## ADDENDUM No. 1

PROJECT: University Medical Center  
CV/CICU Renovation &  
NICU Renovation  
602 Indiana Avenue  
Lubbock, Texas 79415

DATE: 05/12/2025  
PROJECT NO.: 22307 & 22419

15/A8 SIXTH FLOOR - DEMOLITION PLAN - ALTERNATE #1

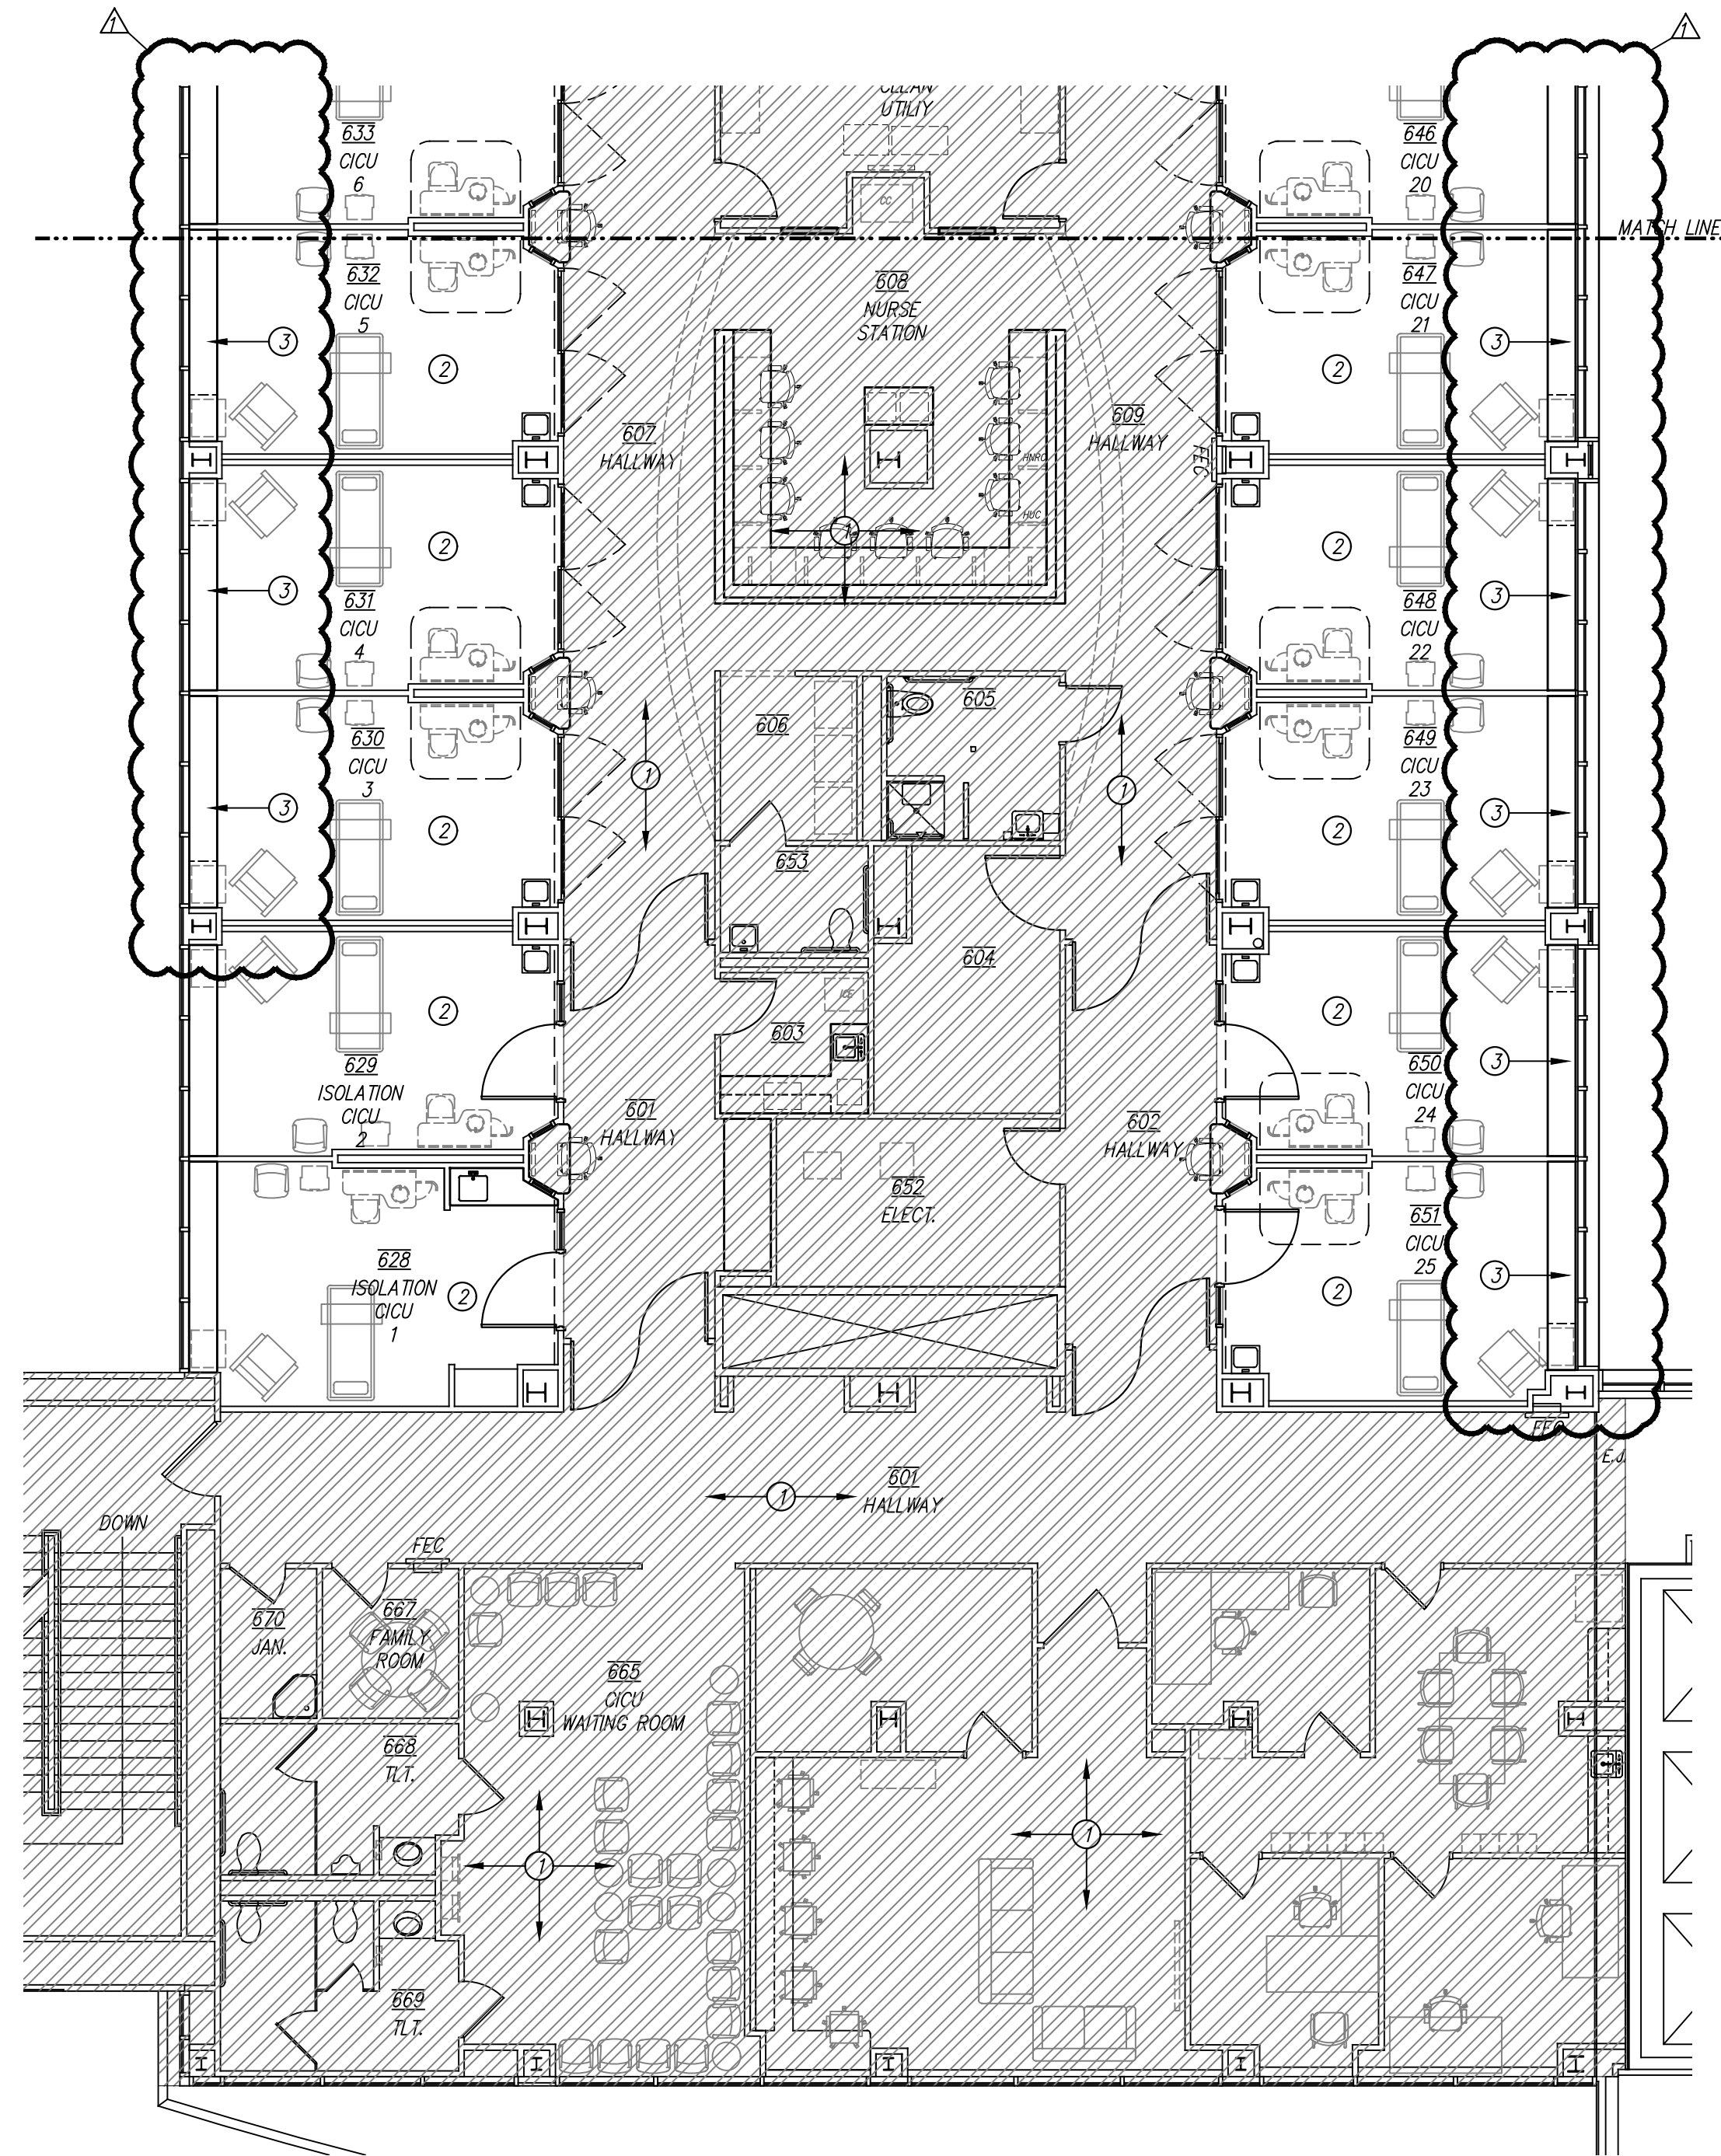
**ITEM #3: Addition of Alternates** – Refer to attached Specification Section 0123000 Alternates. This includes previous Additive Alternates #1-3 and newly added #4A & 4B. Refer to attached Architectural Sheets A8, A10 & A11 and Interior Sheet ID5.

- A. **Alternate #1:** Replace plastic laminate at windowsills in all CICU Patient Rooms, including Isolation Rooms, with solid surface SSM1.

- 1 NO WORK IN THIS AREA.
- 2 REMOVE EXISTING FLOORING AND WALL BASE IN THEIR ENTIRETY. PREP FLOOR FOR NEW FINISH. REFER TO ID SHEETS.
- 3 REMOVE PLASTIC LAMINATE WINDOW SILL/COUNTERTOP AND REPLACE WITH SOLID SURFACE. MILLWORK TO REMAIN, PROTECT DURING CONSTRUCTION.

1/M1 PARTIAL SIXTH FLOOR PLAN - SOUTH - MECHANICAL DEMOLITION

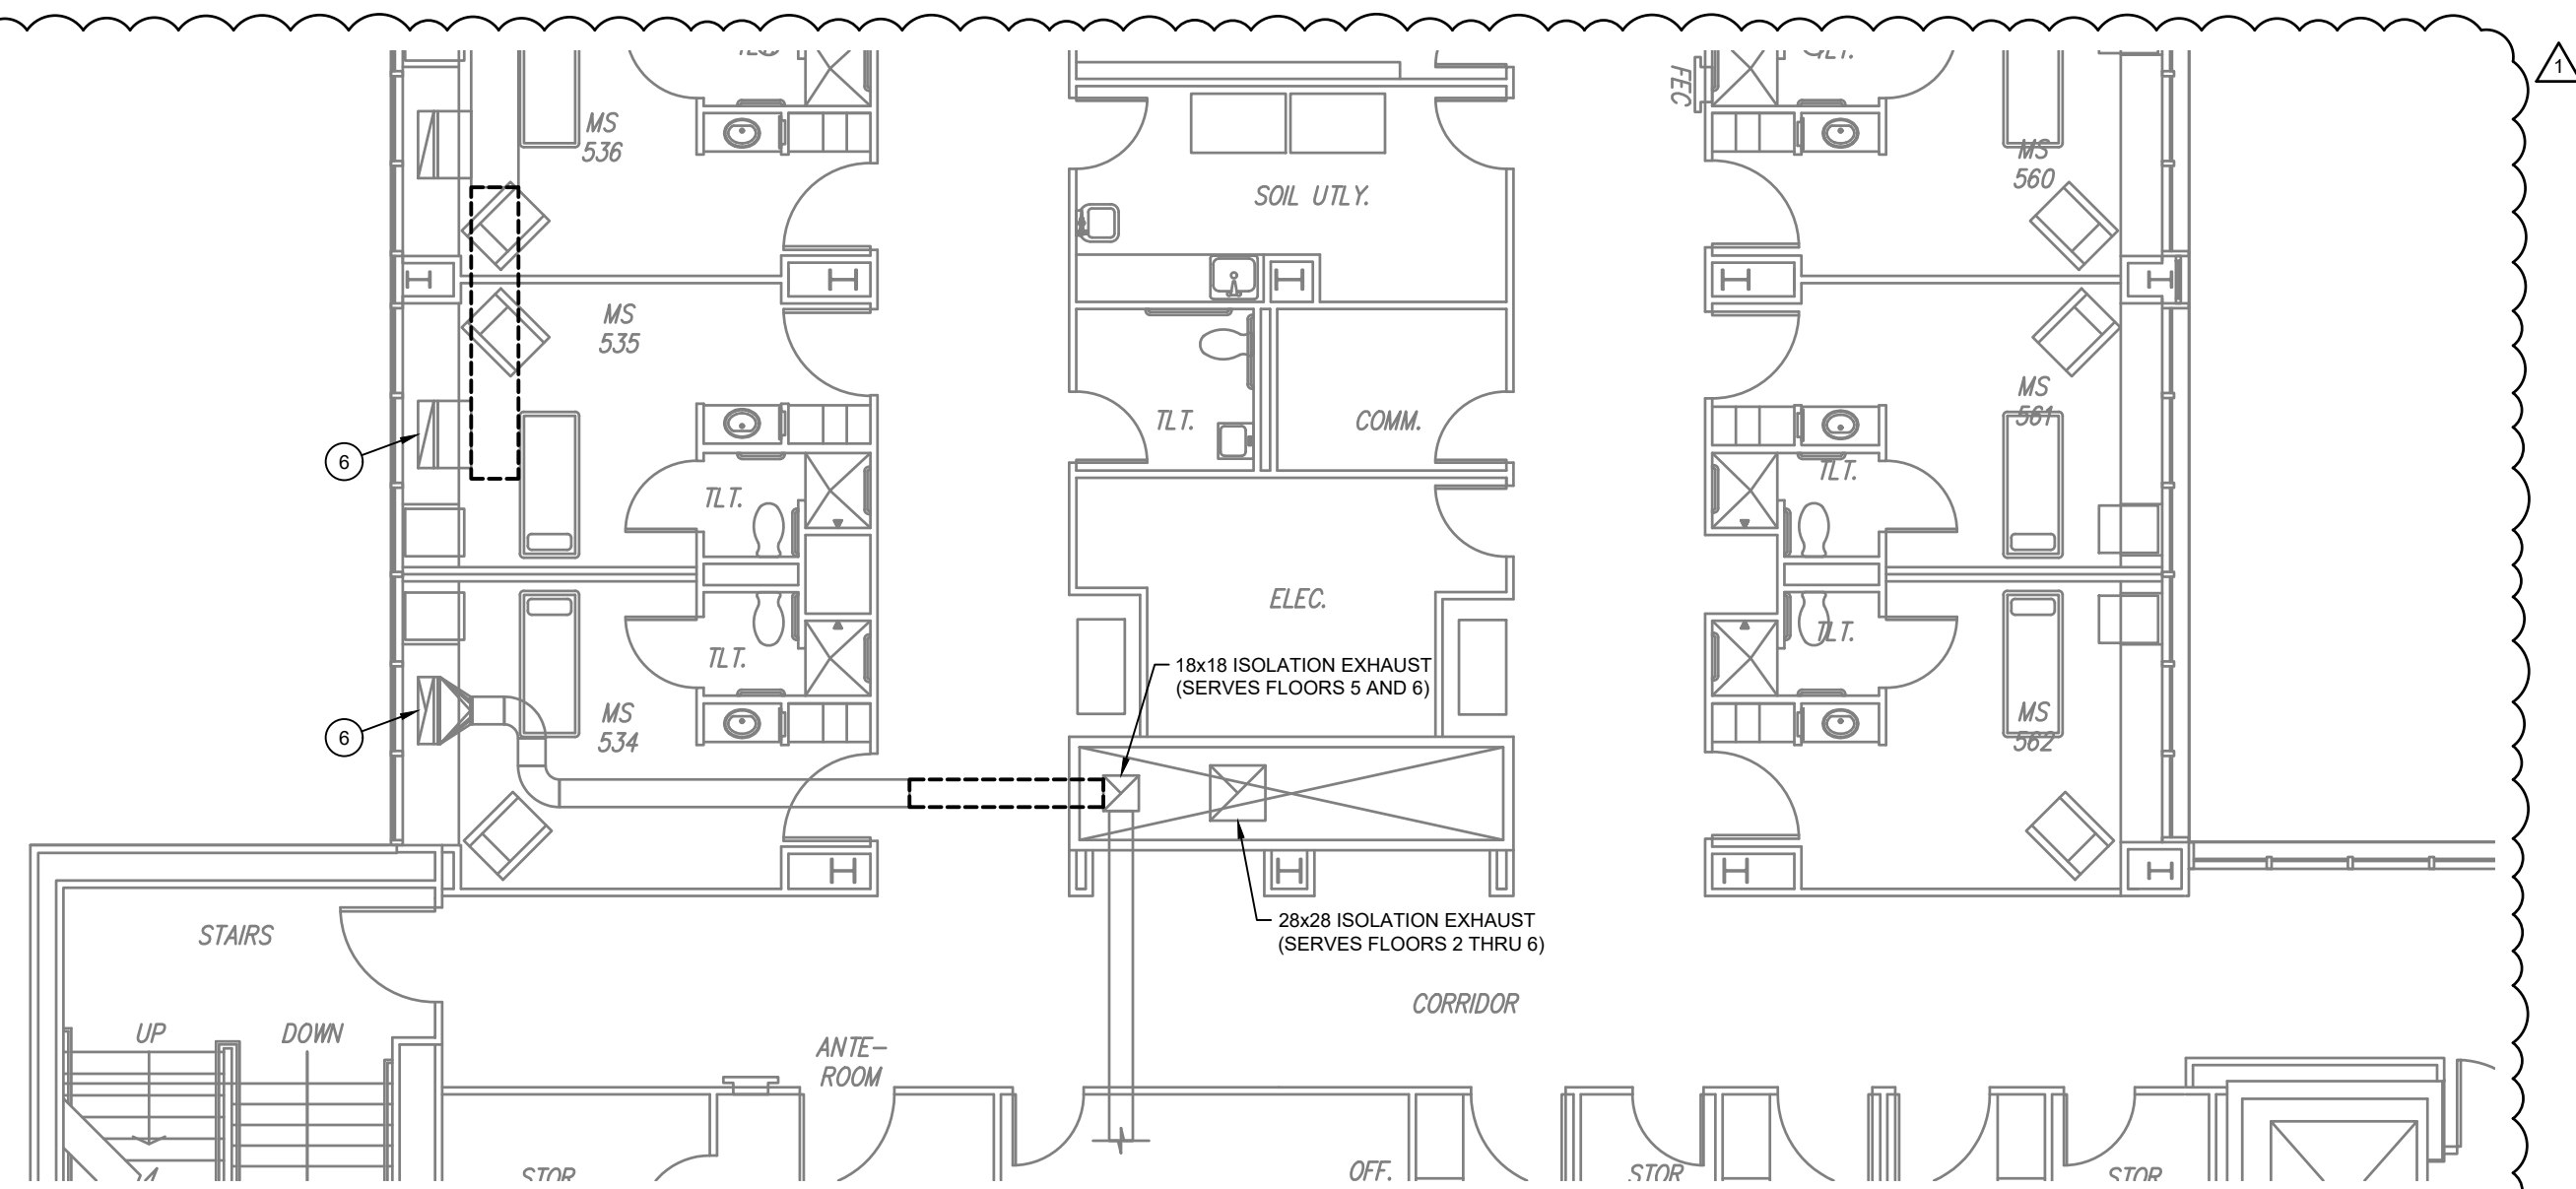
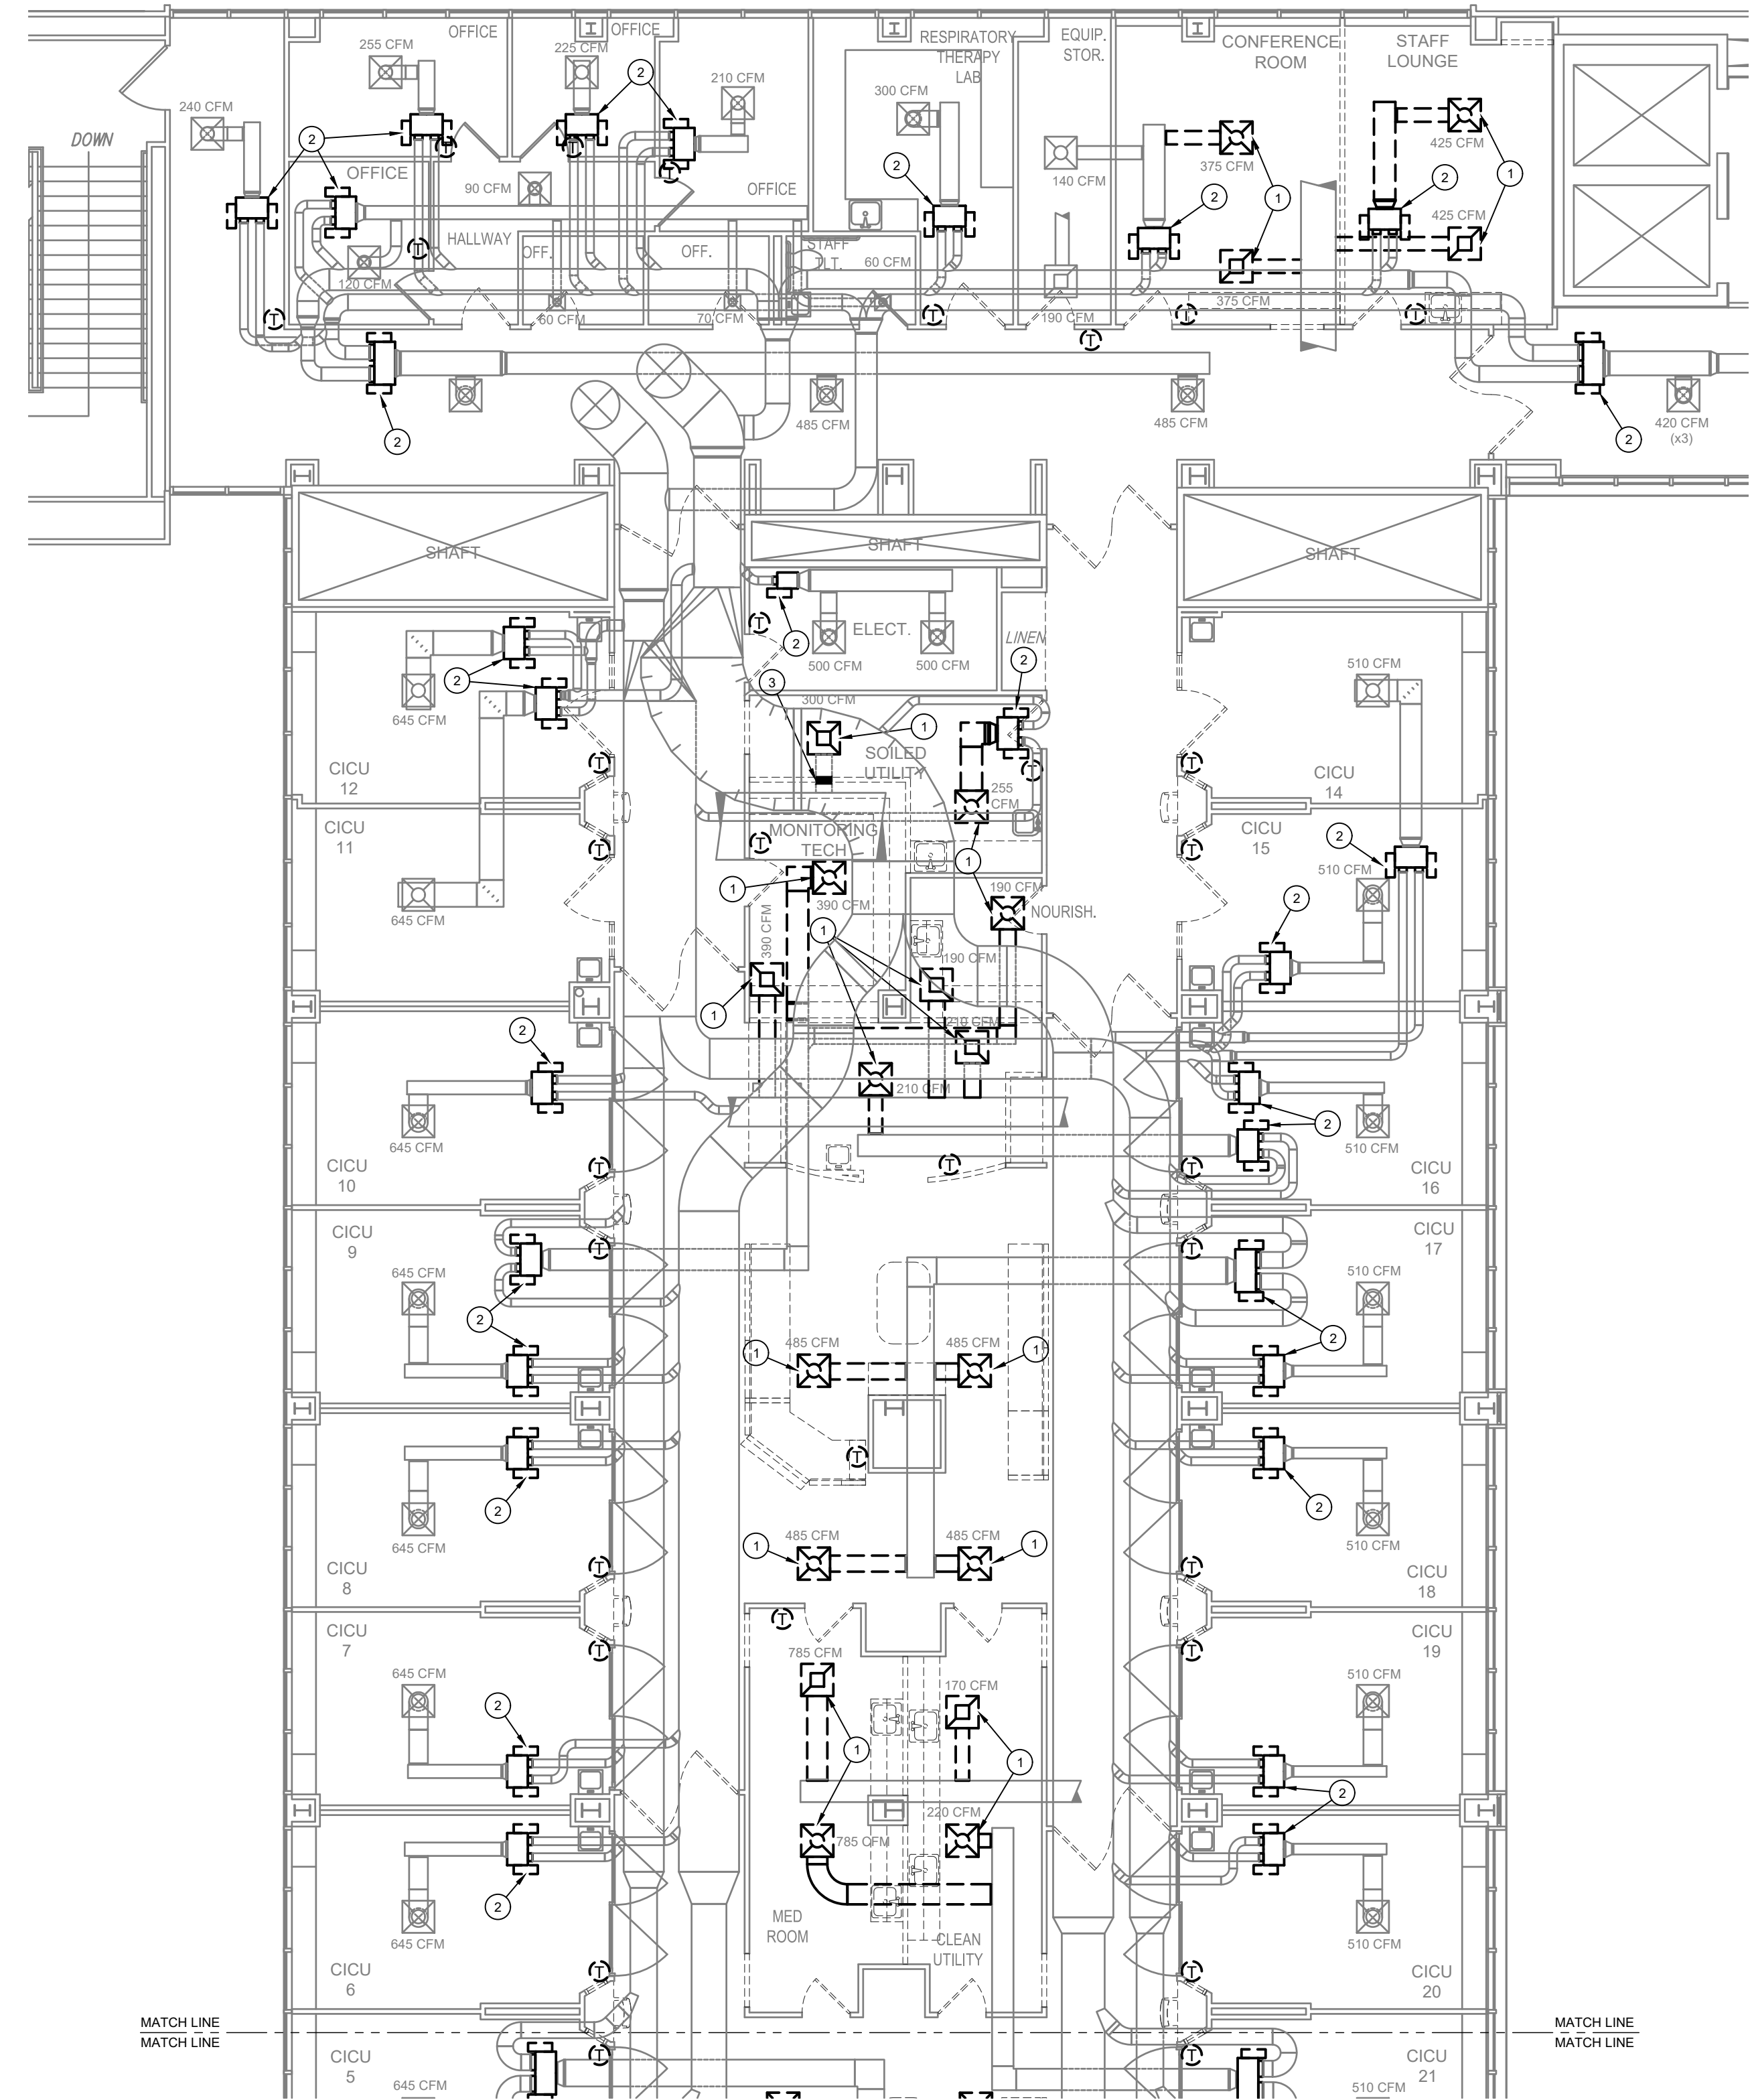
### Item 1. Drawing Sheet M1:

- a. Remove additional ductwork and pressure sensors for CICU 1 and CICU 2 Rooms in order to convert these rooms into Isolation Rooms.
- b. Remove additional ductwork on Fifth Floor serving low exhaust for CICU 1 and CICU 2 Rooms in order to convert these rooms into Isolation Rooms.
- c. Replace existing VAV Box and ceiling diffusers and grilles serving elevator lobby. The VAV Box replacement shall be under Bid Alternate #3. The replacement of the ceiling diffusers and grilles shall be under Bid Alternate #4.

1. REMOVE EXISTING CEILING DIFFUSER/ GRILLE SHOWN DASHED, EXISTING AIRFLOW SHOWN FOR REFERENCE ONLY. MODIFY EXISTING DUCT RUNOUT TO BE REUSED IF REQUIRED.

2. UNDER ALTERNATE BID #3: REMOVE EXISTING PNEUMATIC VAV BOX, SHOWN DASHED, AND ASSOCIATED THERMOSTAT. MAINTAIN EXISTING INLET AND OUTLET DUCTWORK TO CONNECT TO NEW DDC VAV BOX IN SAME LOCATION.

3. REMOVE EXISTING FIRE SMOKE DAMPER.
4. REMOVE EXISTING DUAL DUCT VAV BOX, SHOWN DASHED. REMOVE EXISTING ASSOCIATED THERMOSTAT AND ALL WIRING. MAINTAIN EXISTING DUCTWORK TO CONNECT TO NEW AIR VALVE IN SAME LOCATION.

5. EXISTING LOW RETURN/ EXHAUST GRILLE IN MILLWORK TO REMAIN. EXISTING GRILLE SHALL BE UTILIZED FOR NEW ISOLATION EXHAUST SYSTEM.
6. EXISTING RETURN/ EXHAUST DUCT SERVING LOW GRILLE ON 6TH FLOOR ABOVE. REMOVE PORTIONS OF DUCTWORK SHOWN DASHED IN ORDER TO BE UTILIZED FOR NEW ISOLATION EXHAUST SYSTEM SHOWN ON NEW PLAN.

7. REMOVE EXISTING ROOM PRESSURE SENSOR, SHOWN DASHED.
8. UNDER ALTERNATE BID #4, REPLACE CEILING DIFFUSER/ GRILLE IN ELEVATOR LOBBY.
